VALIDATION OPINION FOR REVISION OF REGISTERED MONITORING PLAN

**Guangrun Hydropower Project in
Hubei Province, P.R. China**

UNFCCC Ref. No. 0904

Figure 1 Line diagram of the electrical wiring system of the project

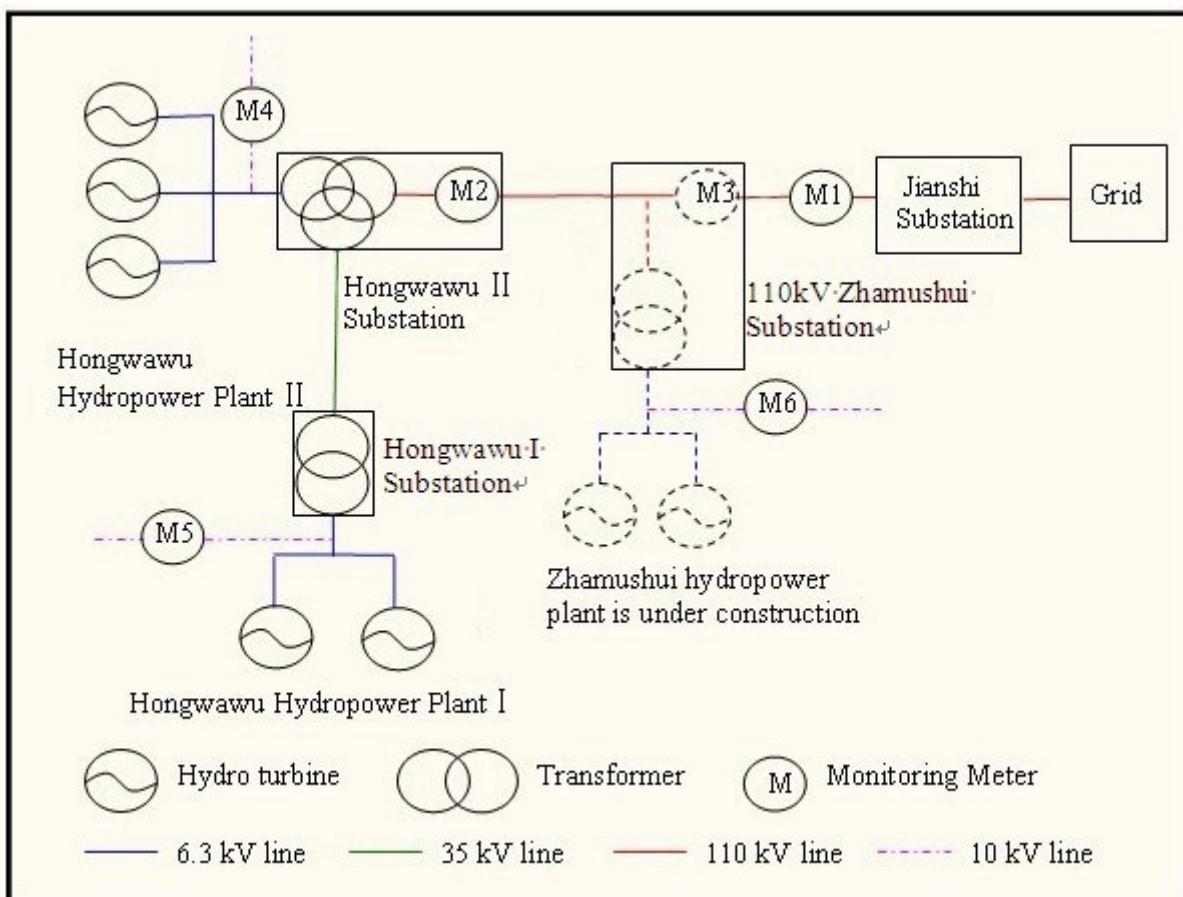
3. In the revised monitoring plan, the electrical wiring system has been detailed according to the actual situation. The project consists of three small-sized hydropower plants (Hongwawu I, Hongwawu II and Zhamushui hydropower plant). Hongwawu II hydropower plant directly connects to 110kV Zhamushui substation through 110kV transmission line, while Hongwawu I hydropower plant connects to Zhamushui substation through Hongwawu II substation, the transmission line between Hongwawu I station and Hongwawu II station is 35kV transmission line. 110kV Zhamushui substation then connects to 110kV Jianshi Substation of the grid through 110kV transmission line. Please refer to the following line diagram of the electrical wiring system of the project.

The electrical wiring system in the revised monitoring plan was verified to be in compliance with the actual implementation (/11/) but deviates from the description in the registered PDD. On page 5 of the registered PDD section A.4.3, it was described that "Hongwawu hydropower plant includes two powerhouses (powerhouse I in 8MW and Powerhouse II in 10MW) and a 4.6 km long 35 kV transmission line to Zhamushui substation" whereas the transmission line is 110kV transmission line which had been verified during site visit.

On page 154-155 of the Feasibility Study Report (FSR, /12/) dated August 2005 which has been validated by the validator, two plans (Proposal A: an onsite 6.3/35kV substation at Hongwawu II and 35kV transmission line to Zhamushui substation where a 35/110 kV substation will increase the voltage to be 110kv; and Proposal B: an onsite 110kV substation at Hongwawu II which will be connected to Zhamushui substation through 110kV transmission line) were proposed for the electrical wiring system between Hongwawu II

substation and Zhamushui substation. 110kV transmission line of Proposal B was chosen by the project company due to its much lower line loss.

Via document review of the FSR, registered PDD, IRR spreadsheet (/13/) which has been validated by the validator, it is confirmed by the assessment team that the investment decision was made on the basis of proposal B, the same was applied in the IRR spreadsheet. It is sufficient to conclude that the description of the 35kV transmission line to Zhamushui substation (Proposal A) in PDD section A.4.3 was actually wrongly quoted by PP when finalizing the PDD at validation stage. Considering the description of 35kV transmission line to Zhamushui substation under registered PDD section A.4.3 was just a typo, it is assessment team's opinion that the project activity has been implemented and operated as per the project design.

The detailed electrical wiring system in the revised monitoring plan is only to make a clear presentation of the monitoring system and is not deemed to be a change to the monitoring system.
